Evaluation of proposed move for Water Right No 21643

Proposed: Move water right no. 21643 a distance of 1619 ft to the southwest.

WELL TEST ANALYSIS

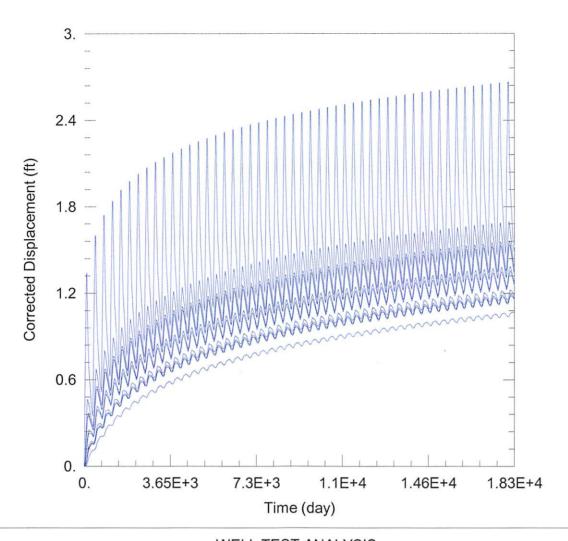
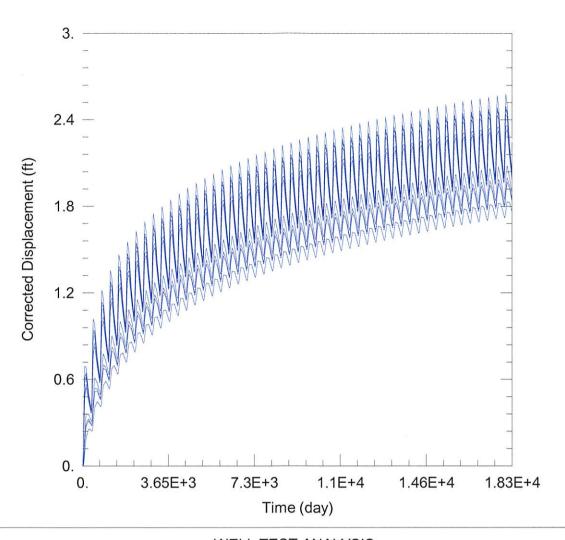
Net drawdown does not exceed the drawdown allowance of 2.0 ft for any wells within 1 mile of the proposed point of diversion, so critical well analysis is not necessary.

The proposed change should result in minimal effects on neighboring wells and is unlikely to create an impairment situation. GMD3 staff recommends approval of the application.
